office memorandum

SUBJECT: Consent to Encroach – No. 1718-4
Lot 2, Block 1, University North Park Professional Center Addition
3501 24th Avenue N.W.

From: Rick McKinney <mckinney@tmparch.com>
Sent: Wednesday, September 13, 2017 11:16 AM
To: Wayne Stenis
Cc: Jane Hudson; Wayne Stenis; Janay Greenlee; Brenda Wolf; Juanitta Goins; Mike Moorman; Bob Goins; Rick McKinney; Brad Goodwin; Dianne Whisler
Subject: Lot 2 Monument Sign
Attachments: 2017-07-20_Lot2_Monument-Sign-Approved-as-Noted.pdf; 2015-7-24_Monument Type E Sign_ARB Approved as Submitted.eml; 2017-4-27_Lot 2 UTC Professional Center_ARB Certificate of Completion Inspection_APPROVED AS NOTED.eml

01 PLAN DETAIL
SCALE: 1/2"=1'-0"

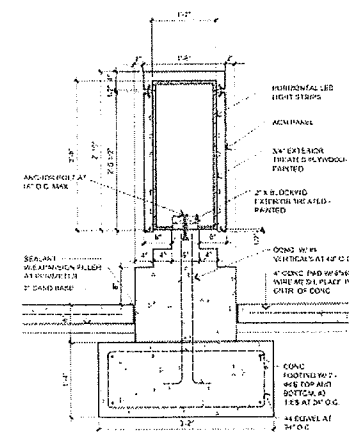
*Finish ?
Texture on
concrete ?*

**UNPC PARTIAL SITE PLAN
BUILDING SINAGE**

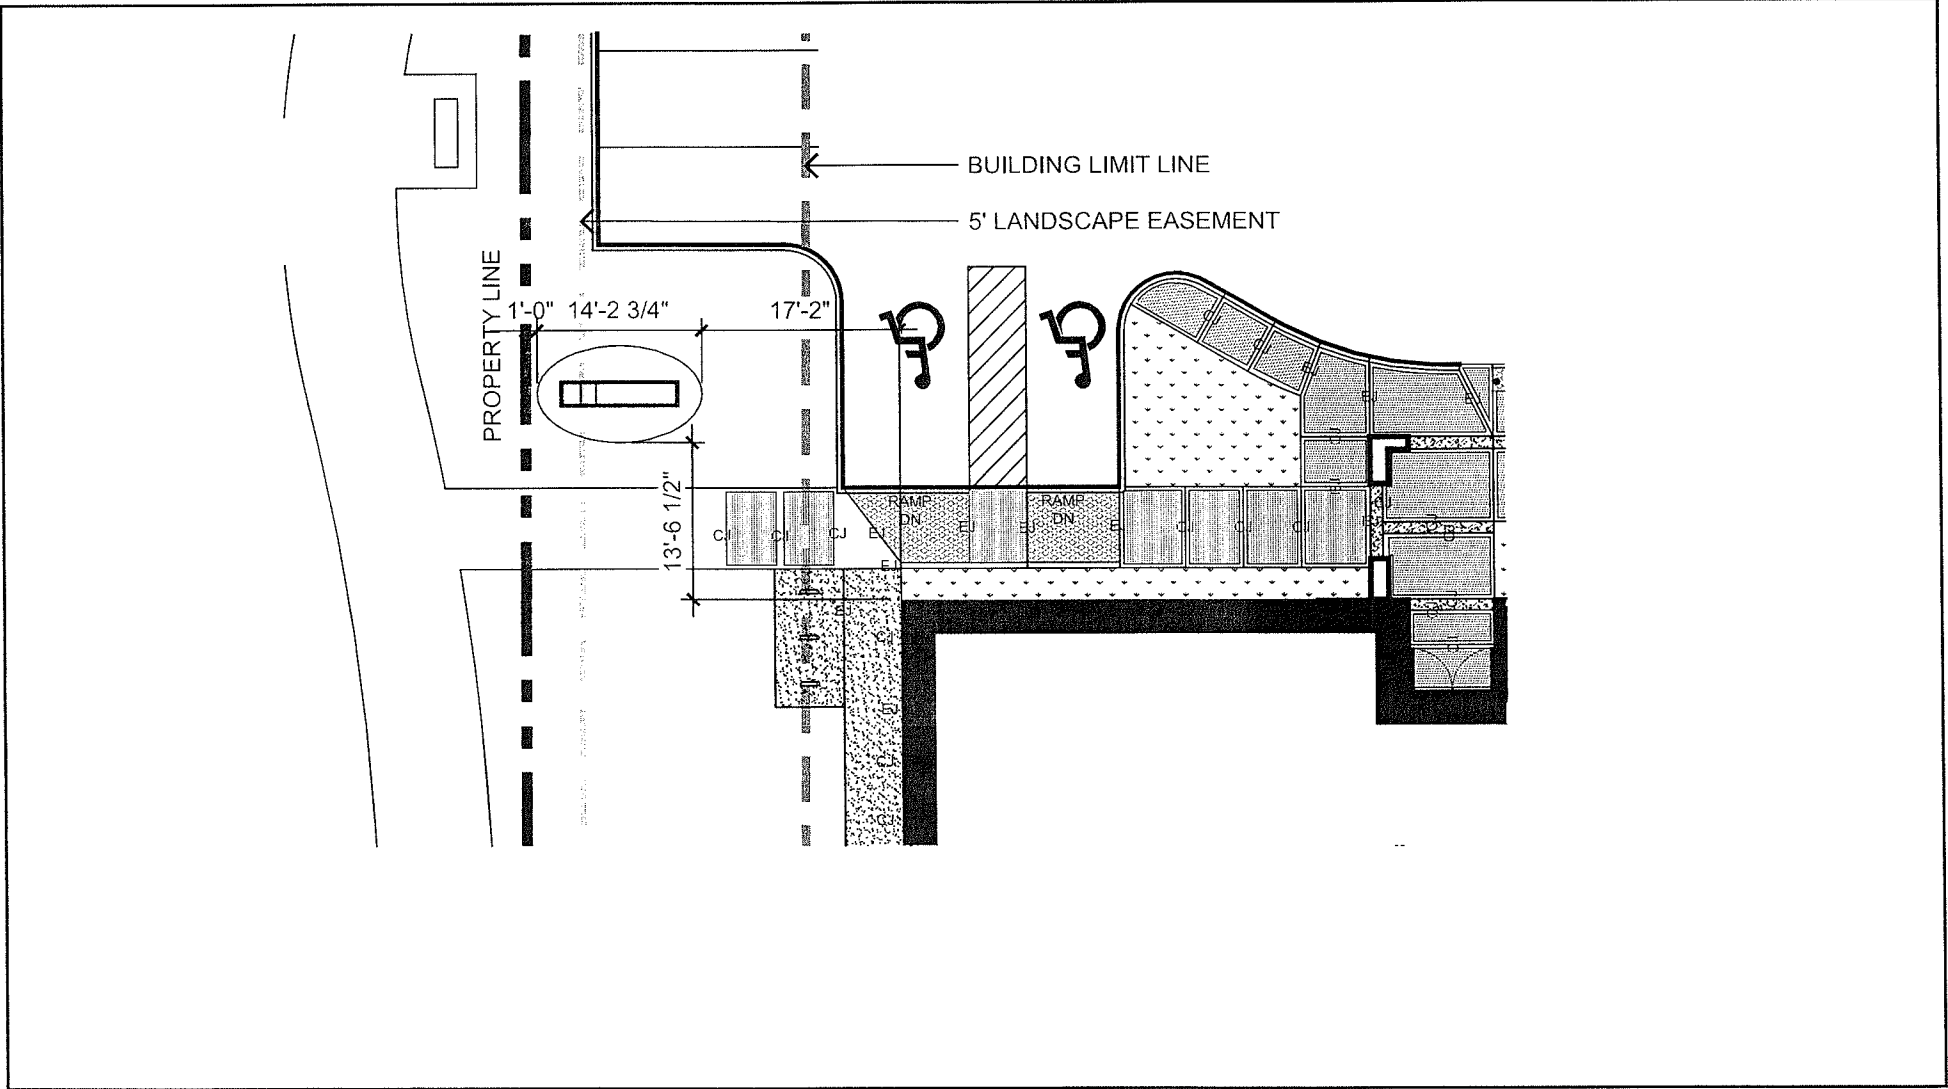
The issue is the placement of the sign...it sets within a utility easement and the footing is apparently already poured.

This was not clear when final design was submitted to us without an updated site plan. The preliminary sign design site plan indicated the sign located outside of the utility easement

While the ARB will allow an exception of this placement, the City should require the Owner to obtain approval letters from all utility companies that may utilize the easement, as was recently required on another project we were involved with.

All future monument signs will be required to be located fully outside of any utility easement. This was not specifically required in the UNP Professional Center Guidelines.
